**Product / Process Change Notification
Produkt-/ Prozess-Änderungsmitteilung**

1. ID No. / ID-Nr.: PPD 03-T118		2. Date of announcement / Datum der Ankündigung: 15.07.2013	
3. Type / Produktgruppe: Energy Varistors	Old ordering code / Alte Bestell-Nr.: B722xxE***	New ordering code / Neue Bestell-Nr.: No change of ordering code	Customer part number / Kundensachnummer:

PCN PPD 03-T118 attachment - Description of EPCOS Barcode

B72232E*** ----- B72248E***

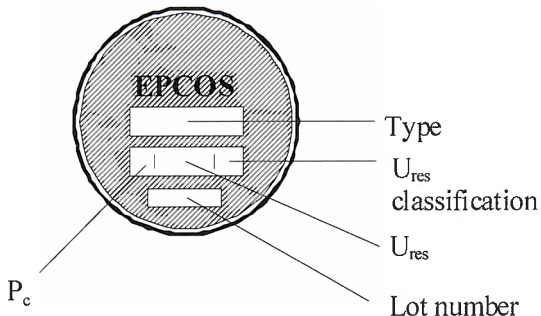
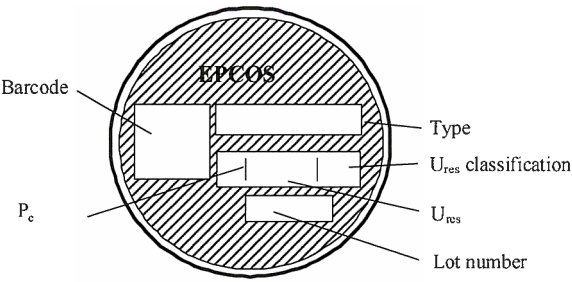
4. Description of change / Beschreibung der Änderung: In addition to today's component marking we add a bar code to support automatization on customer side. See attachment.

Today:	New
	 <p>Description: One Dimensional Barcode -128 Acc. ISO/IEC 15417:2000 Content: U_{res} classification</p>

B72258E*** ----- B72299E***

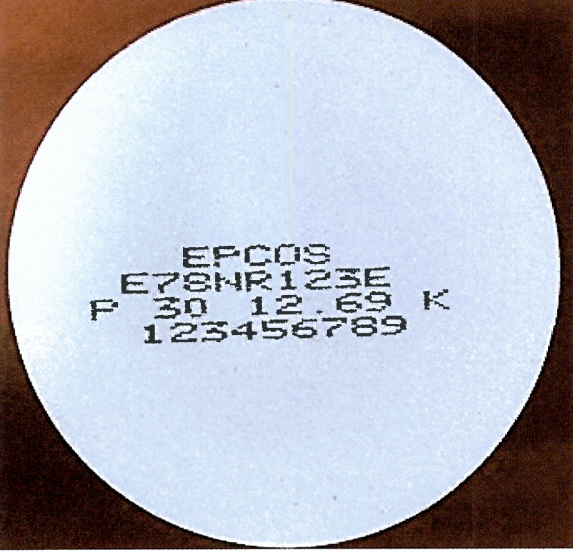
Today:	New
 <p>The diagram shows a circular label with the word "EPCOS" at the top. Below it are three horizontal bars. The top bar is labeled "Type", the middle bar is labeled "U_{res} classification", and the bottom bar is labeled "U_{res}". To the left of the label, a line points to the "P_c" position. To the right, a line points to the "Lot number" position.</p>	 <p>The diagram shows a circular label with the word "EPCOS" at the top. Below it is a square barcode labeled "Barcode". To the right of the barcode are three horizontal bars labeled "Type", "U_{res} classification", and "U_{res}". To the left of the barcode, a line points to the "P_c" position. To the right, a line points to the "Lot number" position.</p> <p>Description: Data Matrix 2D Acc. ISO/IEC 16022 Content: Type, U_{res} P_c U_{res} classification, Lot number, Running number</p>
 <p>A photograph of a circular white label with the following text printed on it:</p> <pre> EPCOS E78NR123E P 30 12.69 K 123456789 </pre>	 <p>A photograph of a circular white label with a square barcode on the left and the following text on the right:</p> <pre> EPCOS E78NR123E P 34 12.76 L 123456789 </pre>
